Sonic Speed TTL Hardware and Wiring Modifications

This document describes the procedure to modify the Sonic Speed Processor (184-00-024) to transmit TTL (5V square wave) boat speed signal.

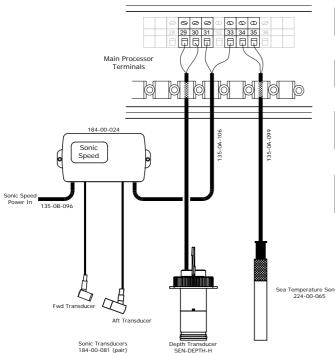
- 1) Switch off power to the system electronics.
- 2) Open up the Sonic processor by removing the six slot-head screws located on the reverse side of the case.
- 3) Carefully remove the PCB from the white support pillars, by squeezing the tabs, and then sliding the PCB off the support.
- 4) Remove R67 (33K Ω) and replace with a 100 Ω resistor.
- 5) Remove C38 (22nF) and replace with a shorting link (piece of wire).
- 6) Remove C39 (10uF) and replace with a shorting link (piece of wire).
- 7) Reassemble the Sonic PCB onto the support pillars, ensuring that the contacts engage correctly with the rear-case connector pins, and replace the cover.
- 8) Re-wire the system as detailed below:

TERMINAL	FUNCTION	CABLE and WIRE COLOUR
	_	
	Depth Transducer	15m cable attached
29	Depth -	Black
30	Depth +	Blue
		•
	Sonic Speed Signal	15m cable (135-0A-106)
31	Boat Speed +	Red (Sonic Speed Terminal 25)
33	Boat Speed -	Blue (Sonic Speed Terminal 26)
	-	Screen not connected
		•
	Sea Temperature Sensor	9m cable attached
34	Sea Temperature Supply	Red
35	Sea Temperature Input	Green
		Blue not connected
